SUBJECT: First Five-Year Review Report  
Piper Aircraft Superfund Site  
Vero Beach, Indian River County, Florida

**First Five-Year Review Report for  
PIPER AIRCRAFT NPL SITE  
The New Piper Aircraft, Inc.  
Vero Beach, Indian River County, Florida**

**December 2003**

Thank you for your submittal of the First Five-Year Review Report (DRAFT). EPA and FDEP have reviewed the document and submit the following comments. The Five-Year Review process is intended, in part, to evaluate the protectiveness of the selected remedial action. According to the details in the report, EPA feels that modifications to the remedial action should be considered by Piper because the UVB wells do not appear to be operating properly and adjustments could be made in the location and monitoring of the monitoring wells to improve the systems efficiency. Please view this comment letter in two respects: First, comments on the report itself (listed mostly in Section 1.) should be addressed so the that the report can be finalized and approved by EPA. Second, comments concerning the potential modifications to the remedial action (Sections 2. through 5.) should be considered in any future work at the site. EPA r

Figure 2

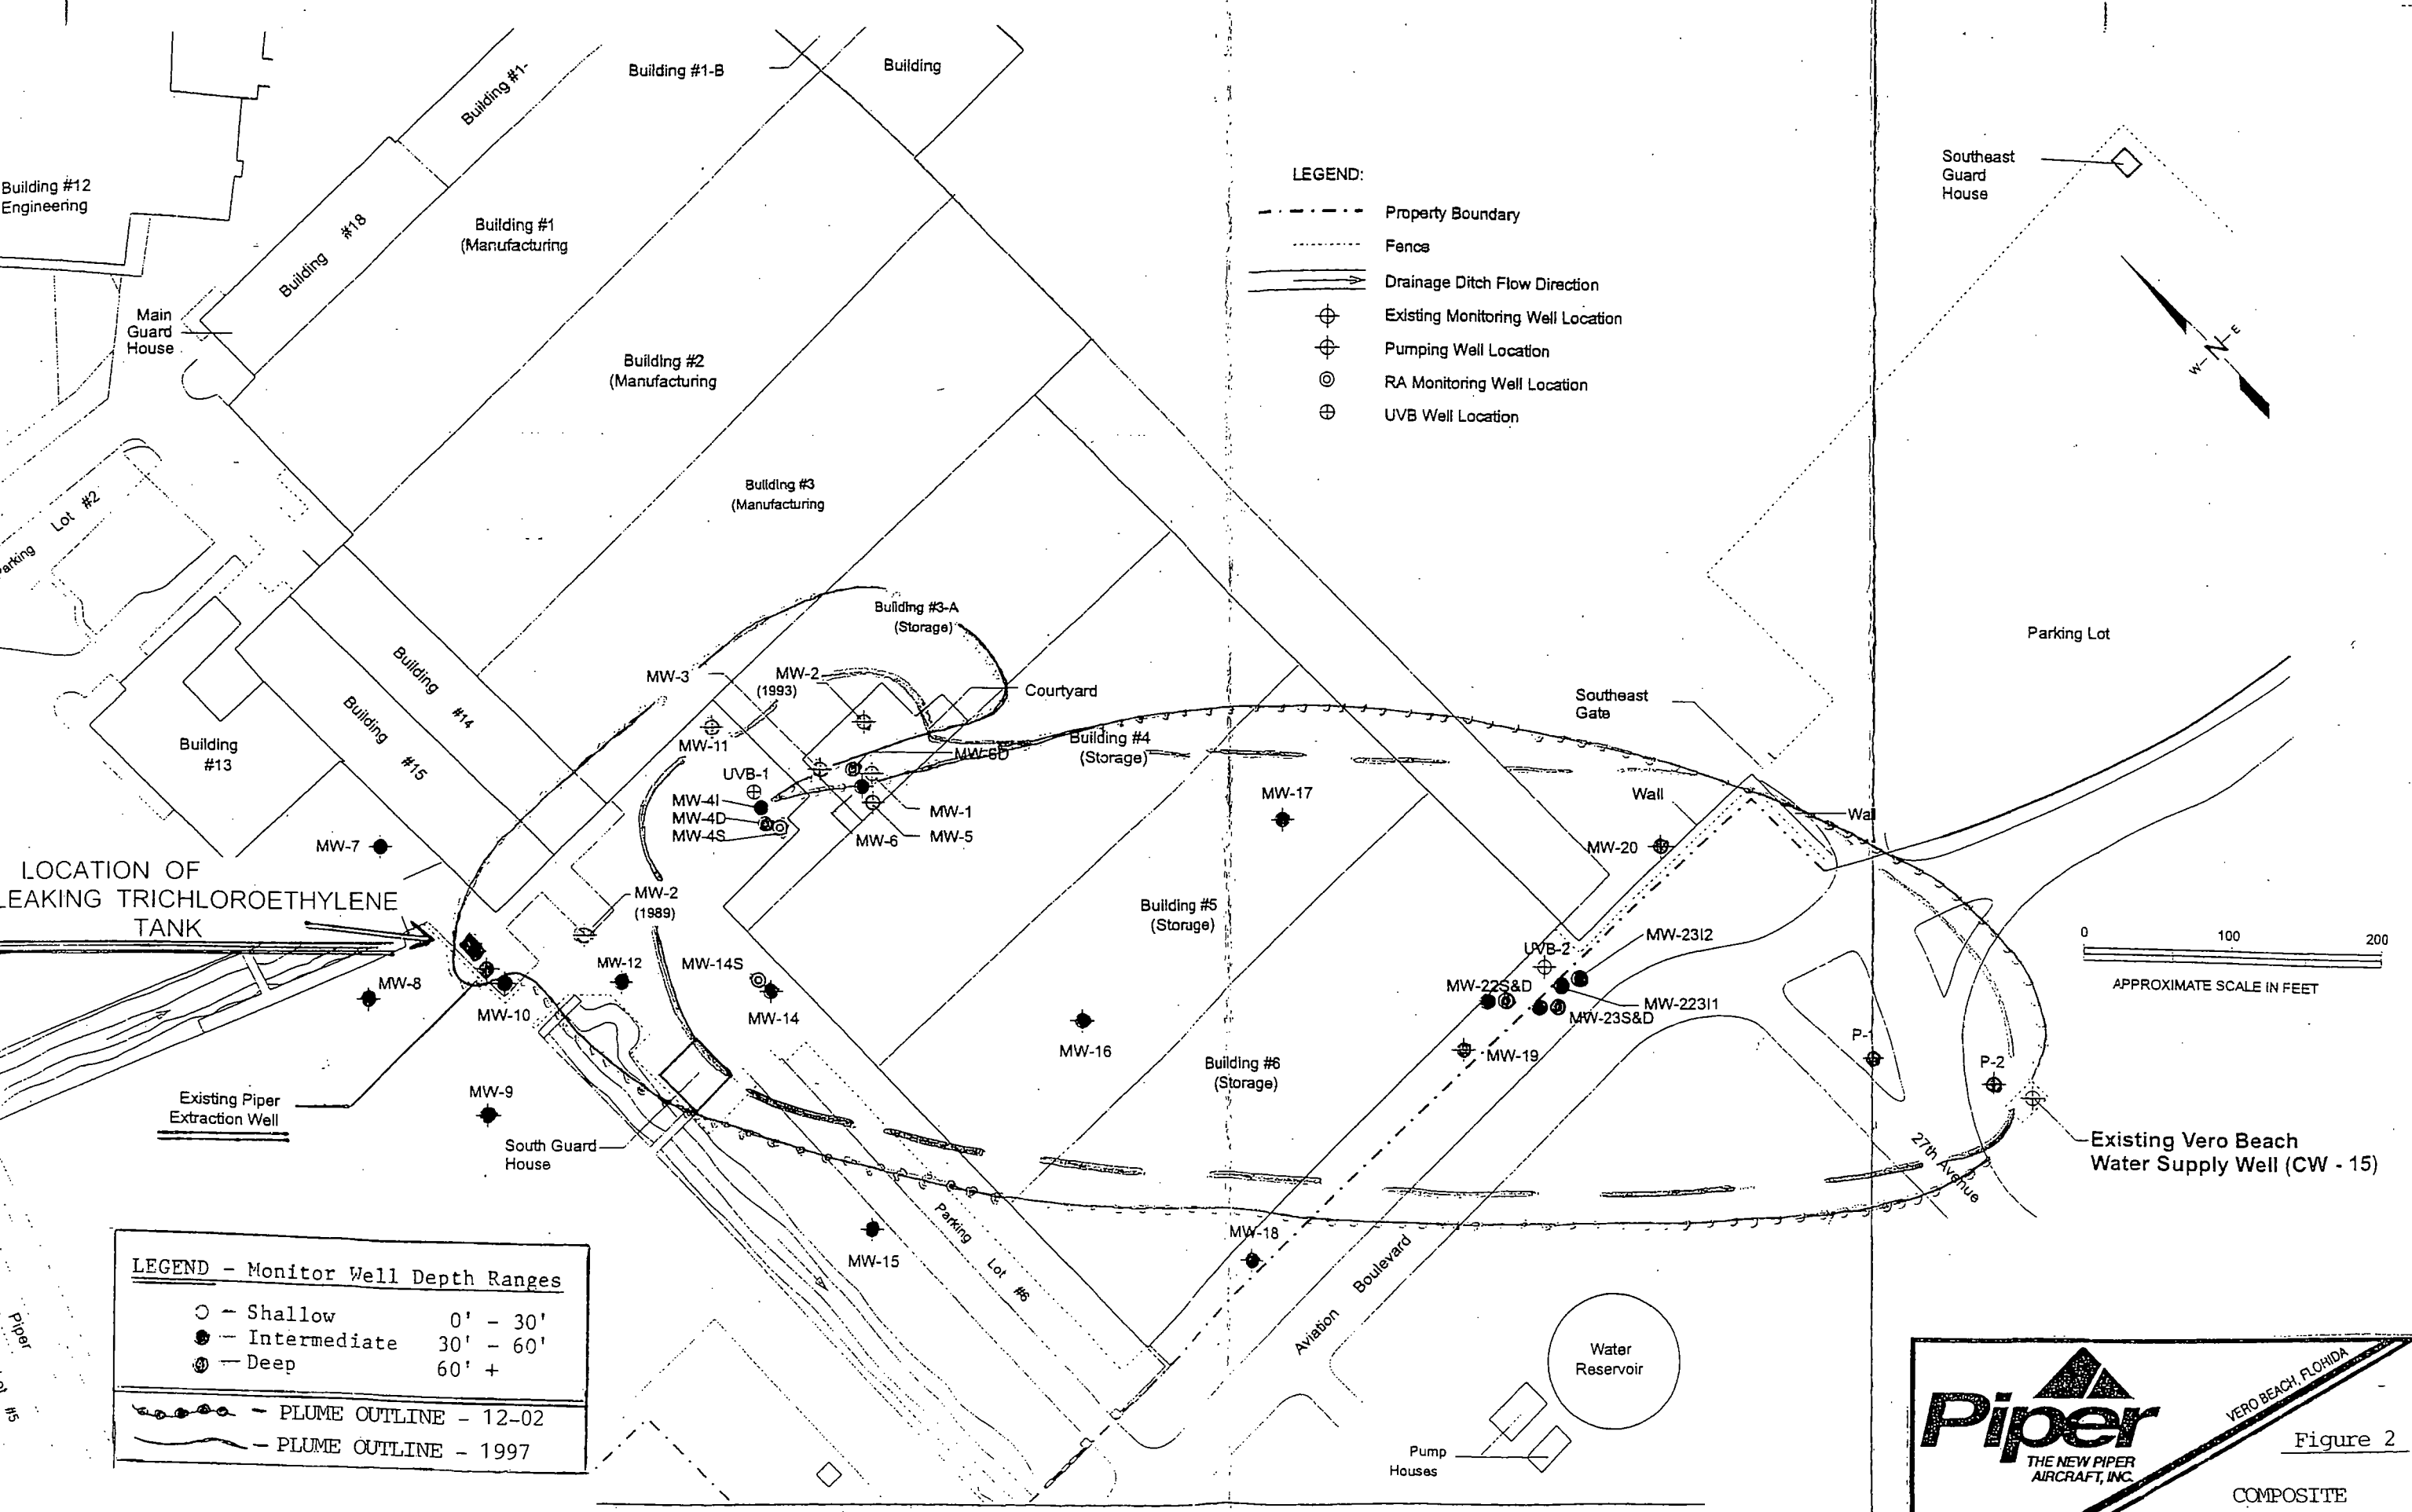
- 3.2 Mid-plume monitoring wells appear to be poorly placed to track the progress of the remedial action. MW-16 is best located to monitor the progress of the remedial action, but data from that well are too variable over the period of UVB well operation to make any reasonable judgement about changes in water quality in the mid-plume area. MW-17 is another mid-plume well and data from that well suggest that the remedial action is having little or no effect on the concentration of vinyl chloride in that part of the plume (Figure 2).

*The MW-17 well area, some distance north of the interpreted axis of plume occurrence contains only low level VC in the intermediate depth range. The area will be included in modified remediation planning with regard to geoprobe tasking and possibly deeper screen placement to check on deeper spreading of contaminants primarily to the northeast.*

COMPOSITE ISOPLETHS FOR TRICHLOROETHYLENE  
COMPARING PLUME CONFIGURATIONS  
JANUARY, 1997 & DECEMBER, 2002

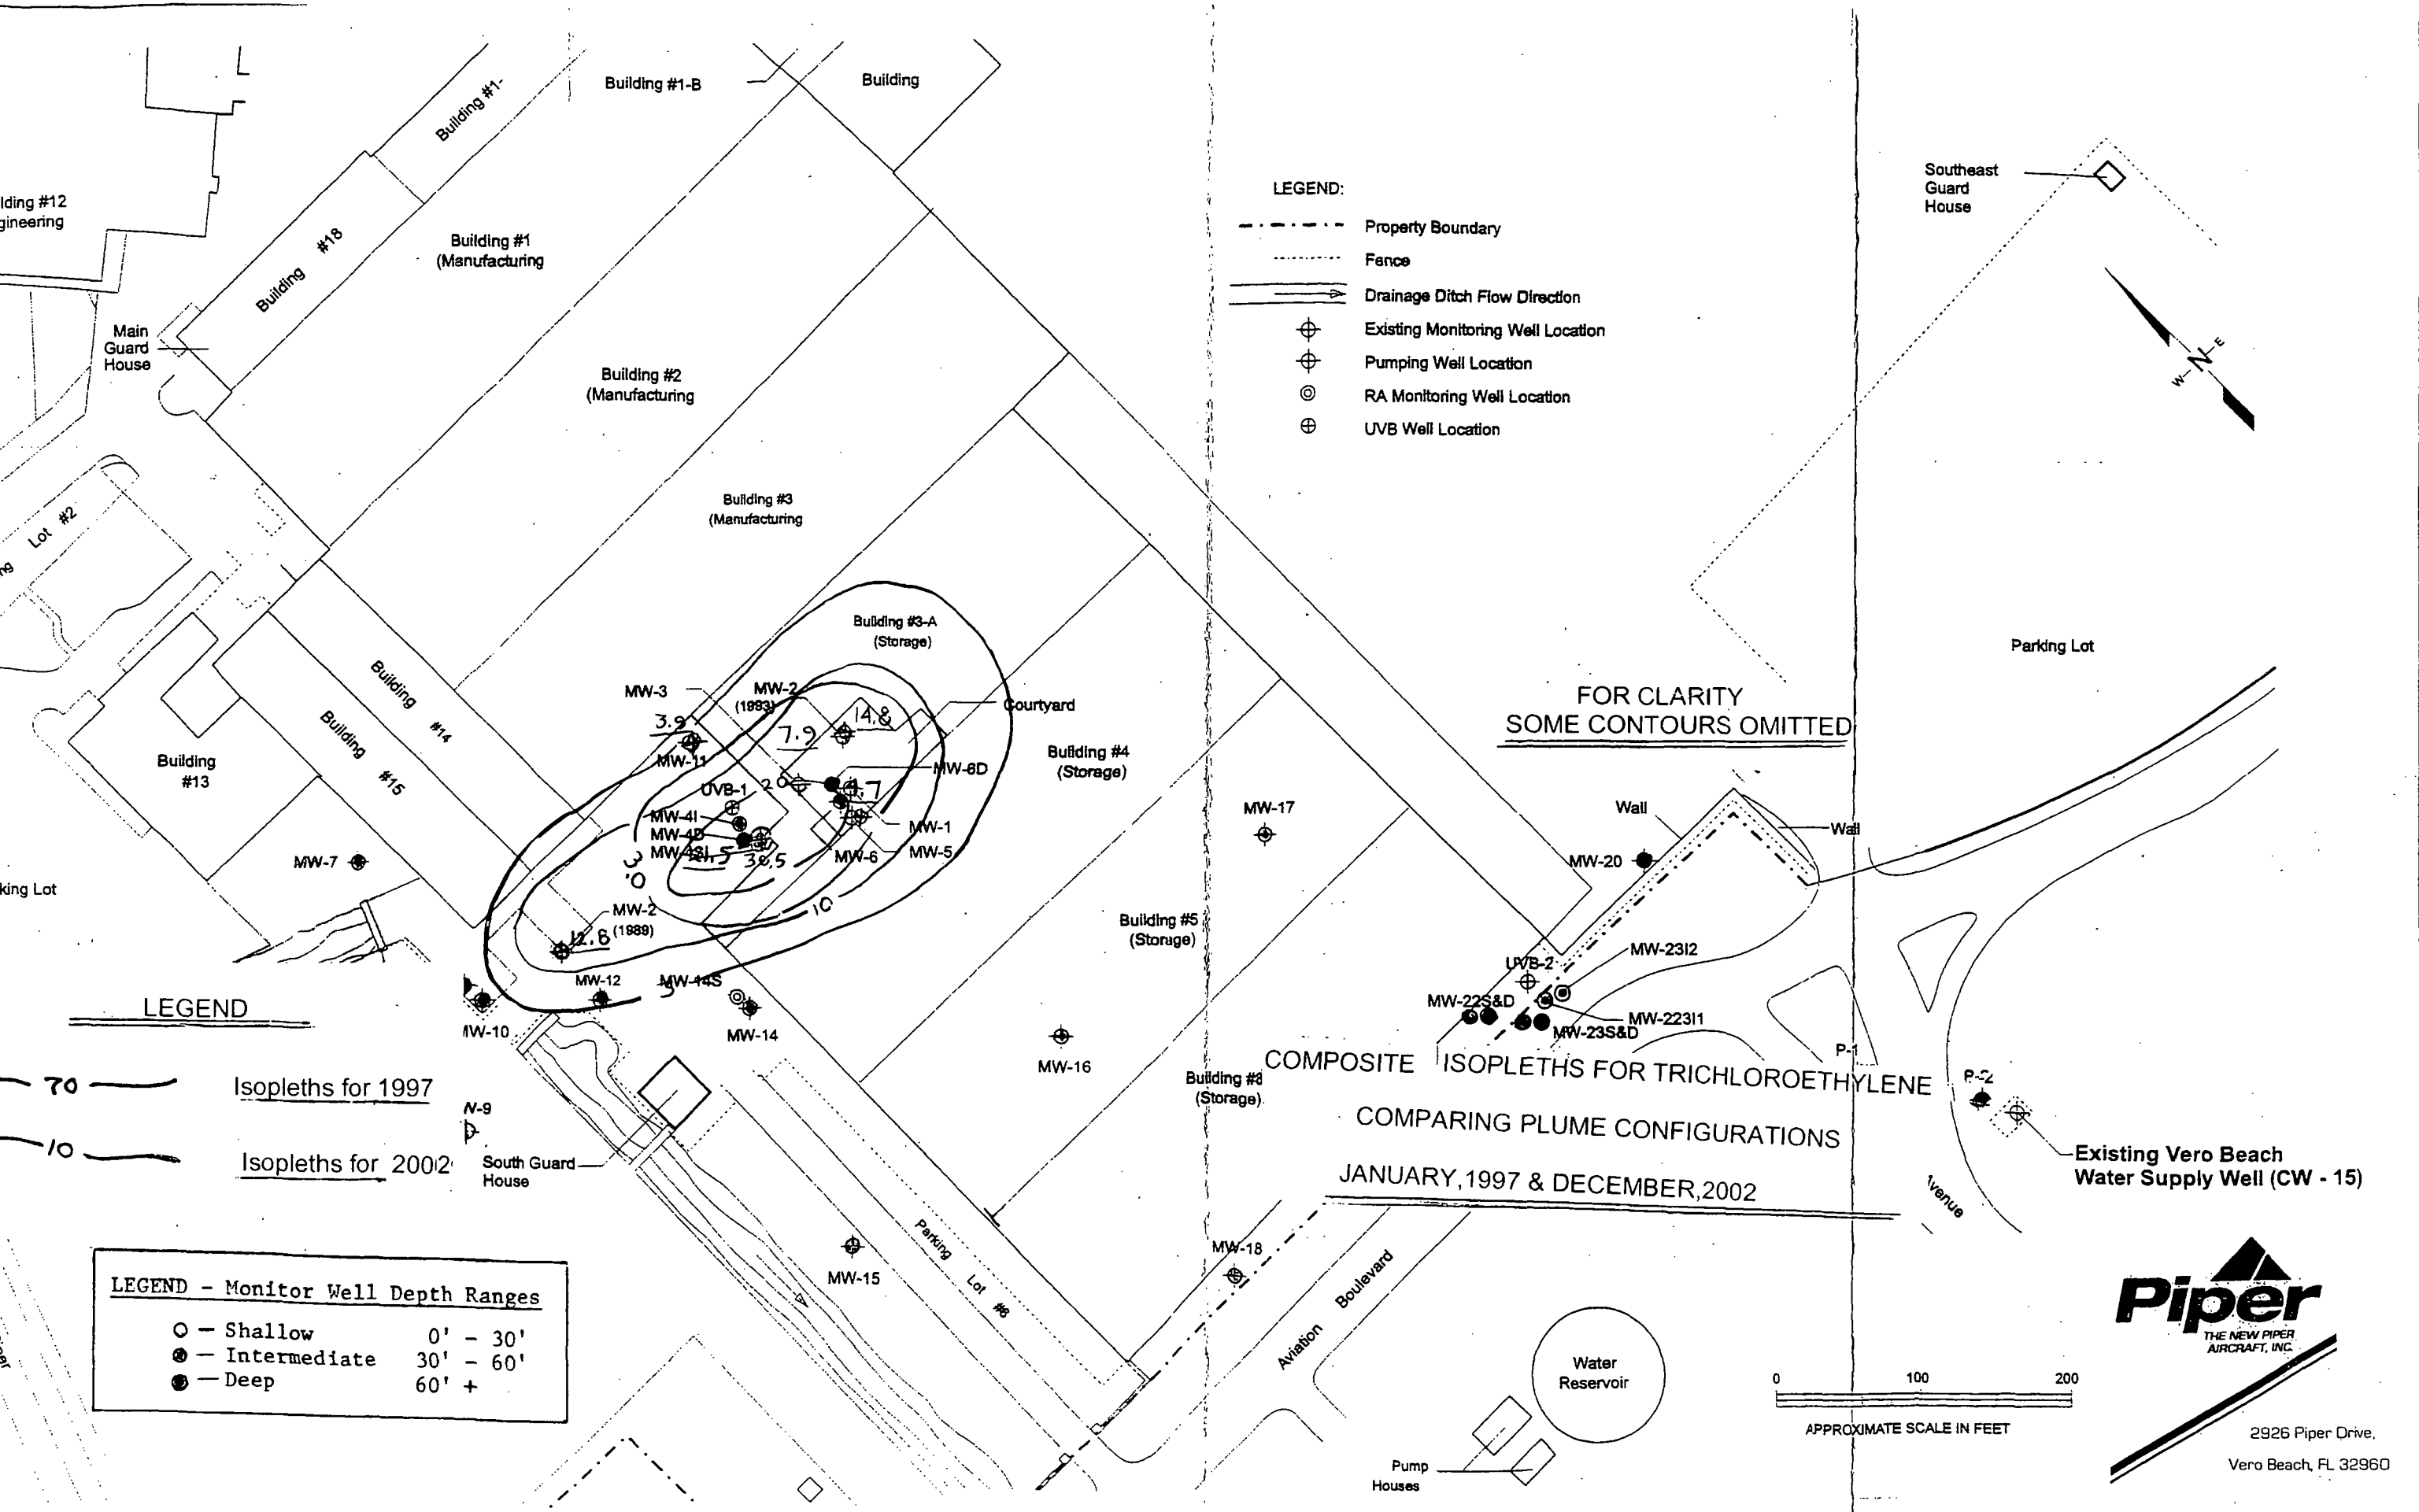
- 1.12 In the discussion of the trichloroethylene contamination on page 19, the text references January 1999. Figure 14 indicates that one set of contours represents conditions in January 1997. This discrepancy should be corrected.
